Proposal #01: 1066-03-75, WISC 2025001
Madison – Lake Mills
CTH N to Airport Road
IH 94
Dane & Jefferson Counties

This is Addendum No. 02, which provides for the following:

ADDENDUM NO. 02

| | | PLOT SCALE: 1 | | SHEET 19 |

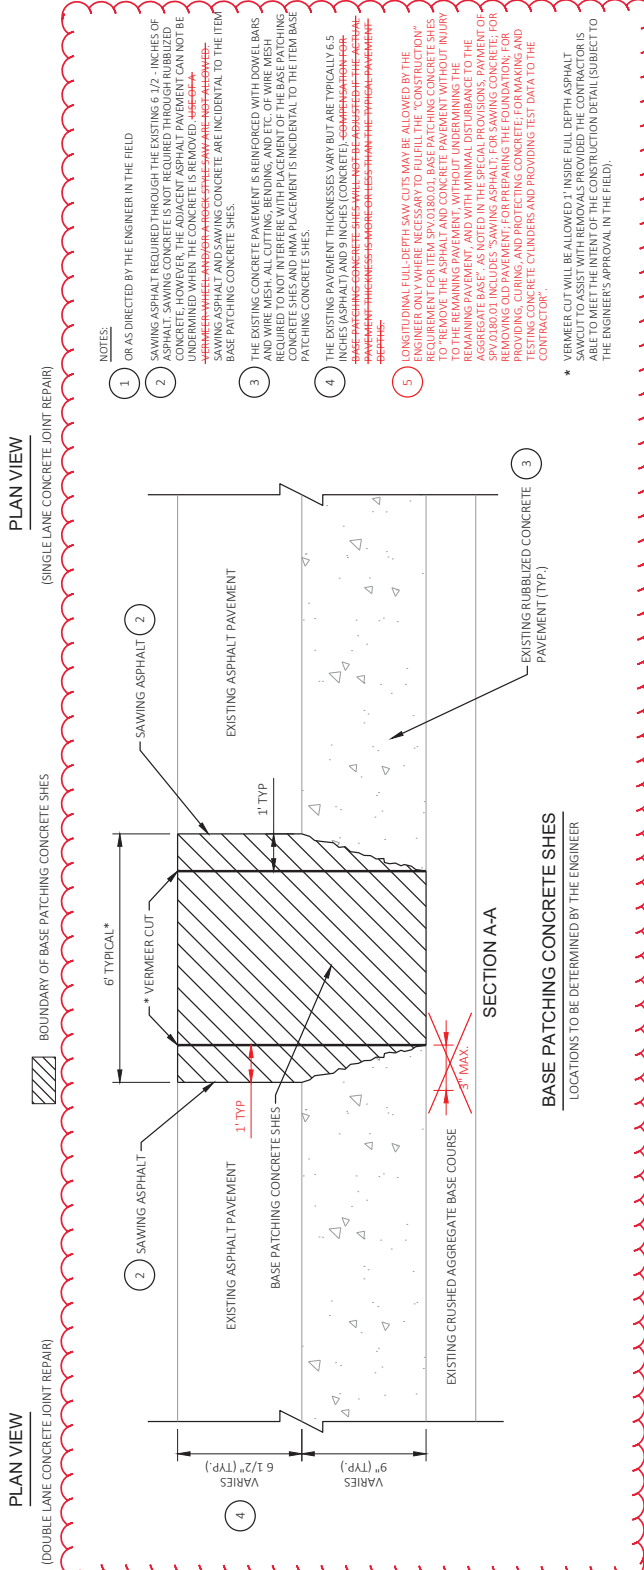
Revised Plan Sheets	
Plan Sheet	Plan Sheet Title (brief description of changes to sheet)
19	Construction Details (Revised detail)
45	Miscellaneous Quantities (Revised the PWL Mix Table)
